ROAM BAR

Date: November 24, 2024  
Project: Roam Bar, 5105 Ballard Ave. NW, Seattle WA  
To: Minh Chau Le, Department of Neighborhoods Board Coordinator  
From: Swoose Studio, LLC  
Re: DOHH-COA-01496, CORRECTION 1

Date: December 5, 2024  
Project: Roam Bar, 5105 Ballard Ave. NW, Seattle WA  
To: Minh Chau Le, Department of Neighborhoods Board Coordinator  
From: Swoose Studio, LLC  
Re: DOHH-COA-01496, CORRECTION 2

## DoN CofA RETROACTIVE APPLICATION

G005

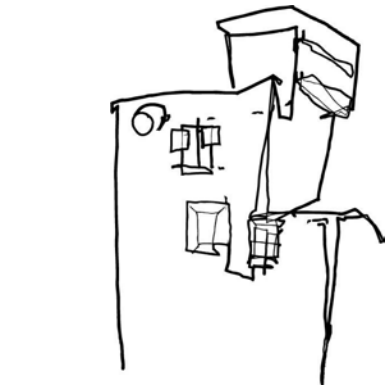
2. Provide the dimensions of the sign, and the dimensions of the new lettering.

4. Provide details about the wood background; is it new or is it from the previous sign? If it's new, what is the materials and the finish? What is the material for the Roam lettering? Is the Roam lettering on both sides of the sign?

RESPONSE: The sign is 18" tall x 29" wide, made of Hemlock 1x that has been charred in character with Shou Sugi Ban wood burning technique and finished with a warm semigloss polyurethane. It is framed by black painted steel, and the letters are red painted steel. Attached in this correction submittal is a technical fabrication drawing for the lettering which has dimensions.

RESPONSE: The framing of the sign is from the previous sign, but the wood infill and Roam signage graphic is new. It's 1x Hemlock burned in the Shou Sugi Ban technique, with a warm semigloss polyurethane finish. The letters are laser cut from 1/8" steel plate and painted red, and the Roam lettering exists on both sides of the sign. Please see photos uploaded with this round of corrections.
